# CARDINAL FREEMAN VILLAGE

Access & Disability Report

**ACCESS REPORT  
PROJECT APPLICATION**

**HOUSING FOR SENIORS OR  
PEOPLE WITH DISABILITY  
(AMDT No. 3 – 2008)**

*Queen Street*

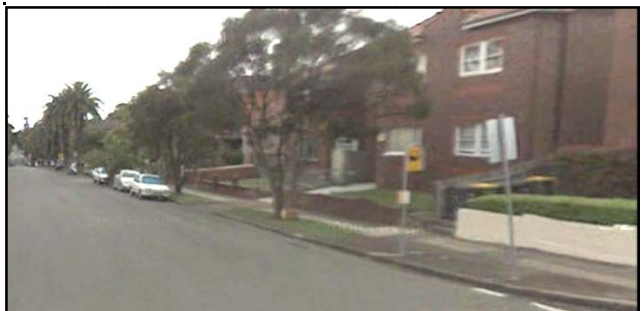
The pedestrian route to the subject bus stops on Queen Street for Route 411 provide moderate gradients of 1:14 and less which complies with clause 26(2)(a) of the Housing for Seniors Policy.

The pedestrian route to the northbound stop incorporates a kerb ramp crossing at the intersection of Queen and Clissold Streets to facilitate appropriate access in accordance with clause 38(a) of the SEPP HS.

### Schedule 3, **Site Access – Wheelchair Access**

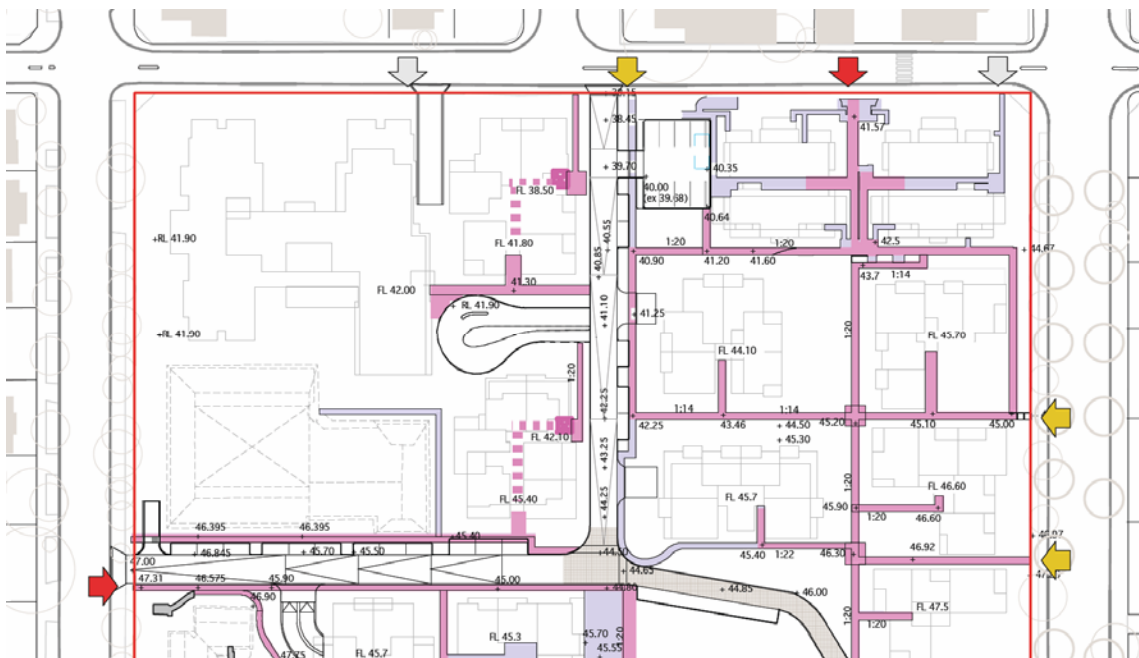
A) Clissold Street Access shall be provided via an accessible path of travel to the Building E foyer entry @RL38.500 which provides lift access to the central courtyard @RL41.800 with moderate 1:20 gradient pathways to Building F foyer @RL42.100.

B) Queen & Victoria Street Access shall be provided from the Building F foyer @RL45.000 which facilitates to access the east-west internal roadway level @RL45.400.

### Section 3B – Chapel Building

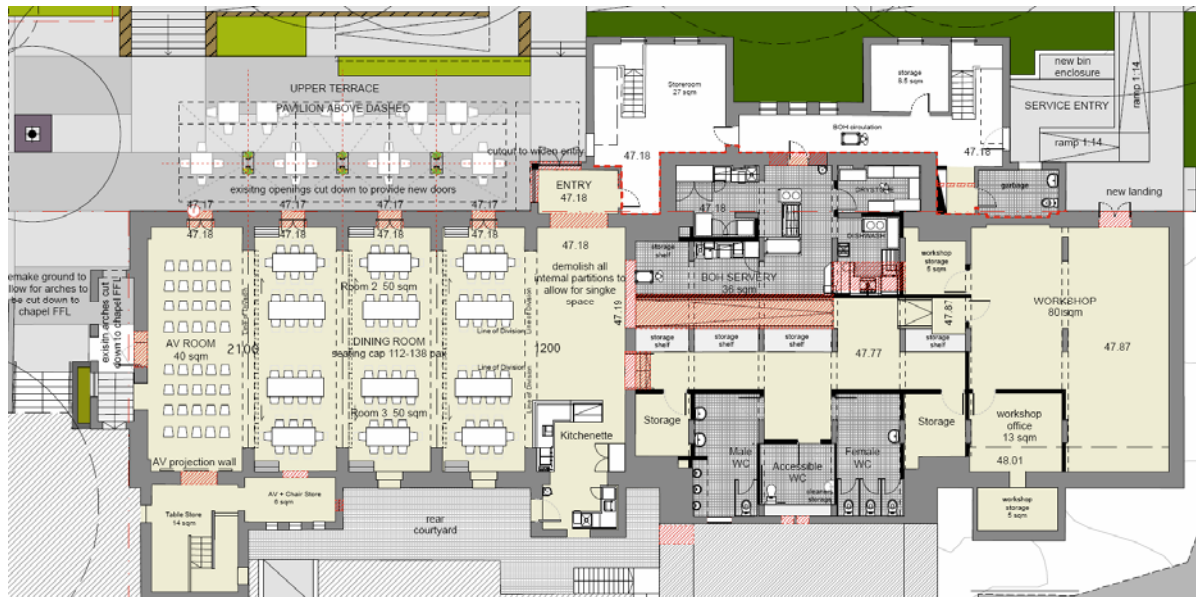
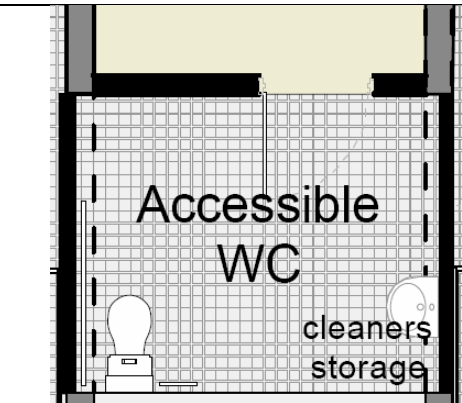
BCA Compliance	Complies
D) <b>Dining Room &amp; AV Cinema Room-</b> The development proposes a communal Dining area on the entry level which continues to an AV Cinema area at the western end which can be separated by a movable wall system. The open plan area is directly accessible from the entry doorway in accordance with AS1428.1 to satisfy Part D3.3 of the BCA.	<b>YES</b>

E) <b>Kitchenette</b> – The kitchenette is situated adjacent to the Dining area and provides adequate access to residents for tea making if required.	
F) <b>Internal Access: Sanitary Facilities &amp; Workshop</b> – To facilitate the 590mm change in level from the entry level @RL47.180 the plans show a 1:14 gradient ramp which will enable appropriate access to the sanitary facilities @RL47.770 followed by a step ramp to the Workshop level @RL47.870.	<b>YES</b>

G) The access to these facilities provides appropriate doorway circulation spaces that will comply with AS1428.1 and hence Part D3.3 of the BCA, including a 1500mm minimum width doorway landing to access the Workshop, which can be easily provided at CC stage.	<b>YES</b>

BCA Compliance	Complies
<p>K) <b>Toilets</b> – The unisex accessible toilet provides an area of 2500mm x 3000mm and is designed in a manner that complies with AS1428.1 to satisfy Part F2.4 of the BCA.</p> 	<b>NO</b>
